DRI REGIONAL REVIEW FINDING

Name of Proposal: Brookside Mixed-Use DRI 4317 Submitting Local Government: City of Alpharetta

<u>Description</u>: A DRI review of a proposal to construct a mixed-use development with new construction of 350 multifamily residential units, 90 townhomes, and 60,000 SF of retail/commercial space along with redevelopment of an existing 130,000 SF office building on a 19.7 - acre previously developed site west of Brookside Parkway and south of Old Milton Parkway in the city of Alpharetta in Fulton County.

BROOKSIDE MIXED-USE DRI

DRI SITE PLAN HEET NUMBER

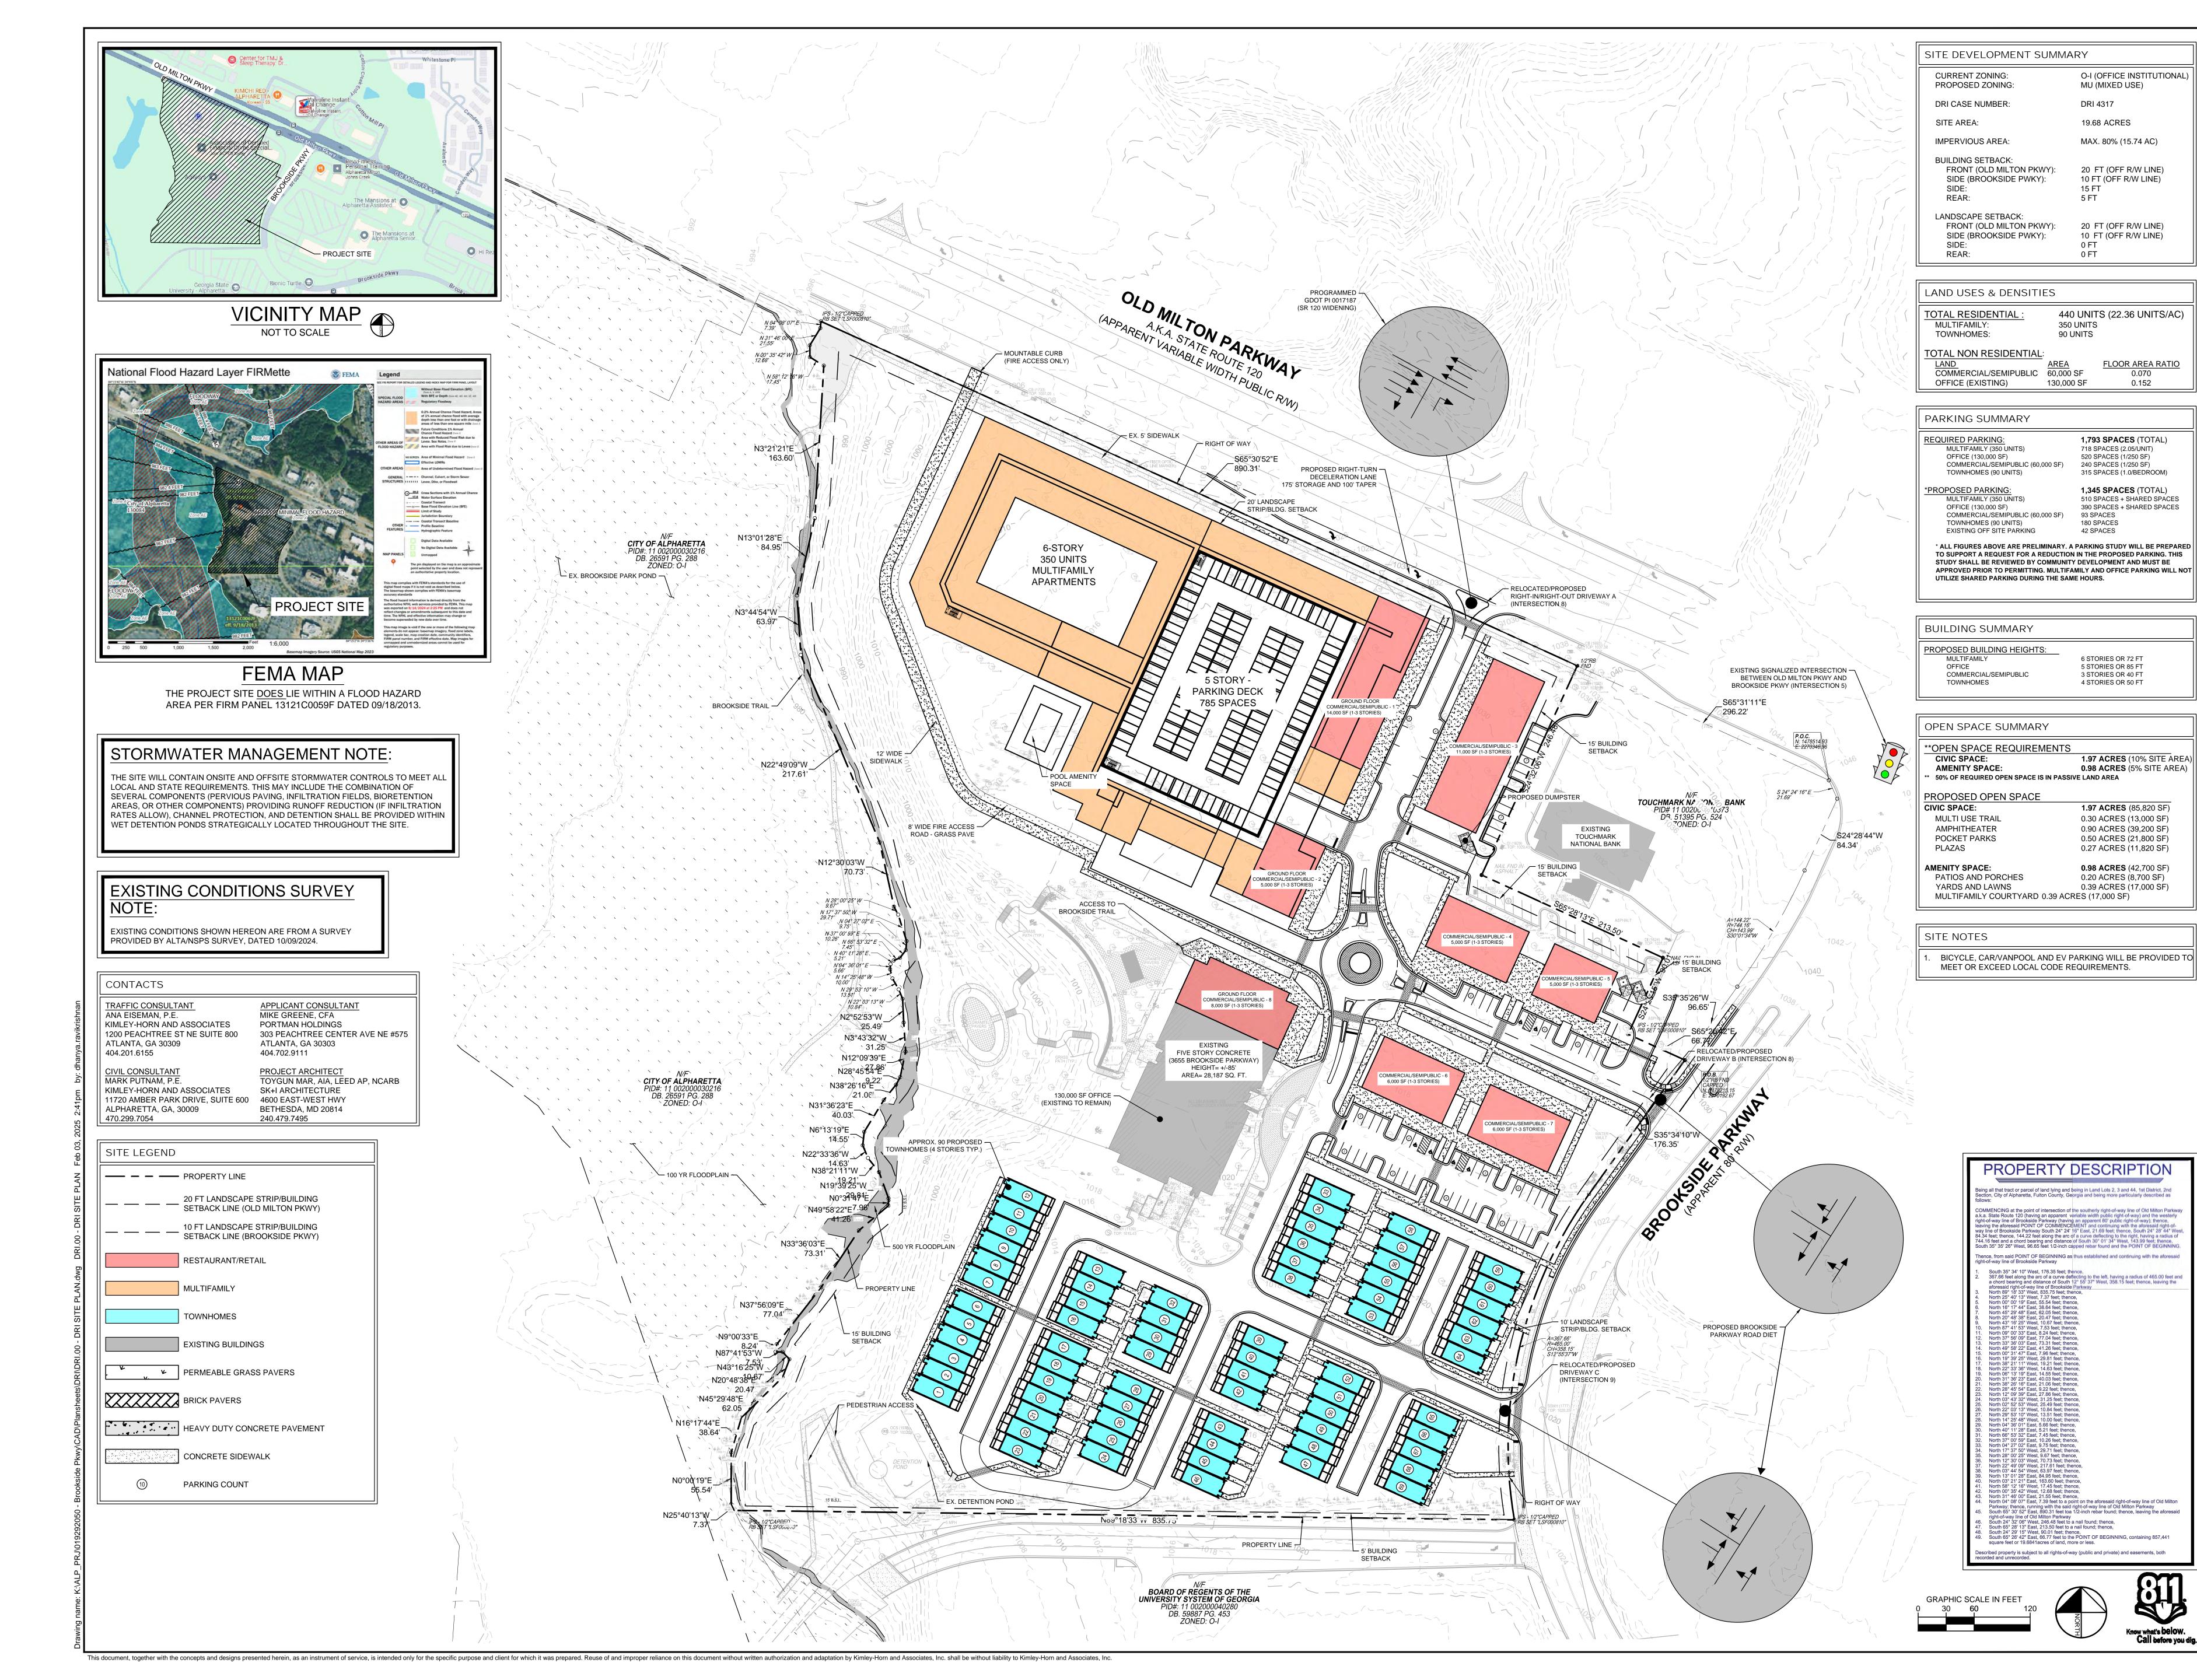
The project's proximity to the adjacent 30-acre City of Alpharetta Brookside Park and trail offers valuable recreational and enjoyment of nature opportunities for residents and visitors. The existing terraced feature extending from the site down to the trail is a principal urban design feature of the existing development that is visually compromised by the narrow opening in between the two existing office buildings. The demolition of the northern office building offers the opportunity to make this much more of an inviting visual and functional portal to the natural amenity. However, the site plan shows a service driveway to the new multi-family building taking up much of this newly opened up space. The inclusion of a large roundabout typically utlized in higher traffic locations and intersections as a traffic management mechanism also diminishes this key pedestrian connection.

Ideally, the site design could be refined to create a stronger visual and pedestrian connection from the natural area to the retail/food plaza buildings flanking driveway B. Patrons of the restaurant/retail area would be invited by the design to stroll to the amphitheatre area with its views and steps down to the trails.

The overall ambiance of the driveway B pedestrian area would also substantially be improved by shfting the surface parking spaces away from the front of the north building so that it mirrors the configuration of the south side. This would allow for outdoor seating facing a greenspace rather than parked cars.

A 12' pedestrian path is proposed to align with required life safety (fire) access along the northwestern frontage of the site. The proposed pedestrian connection will provide improved connectivity between the western edge of the site and Old Milton Parkway sidewalks as well as a connection to the Brookside Trail network and the commercial village on the site.

The site plan provides connections with adjacent parcels, but proposed streets should be better aligned with existing streets. Proposed new intersections may be too close to the southern street intersection that connects to Brookside Pkwy.

Pedestrians are able to move between destinations within the development safely and conveniently. Dedicated bike facilities are not provided. Streets could have bike sharrow markings to allow for bike movements within the site and to surrounding areas.
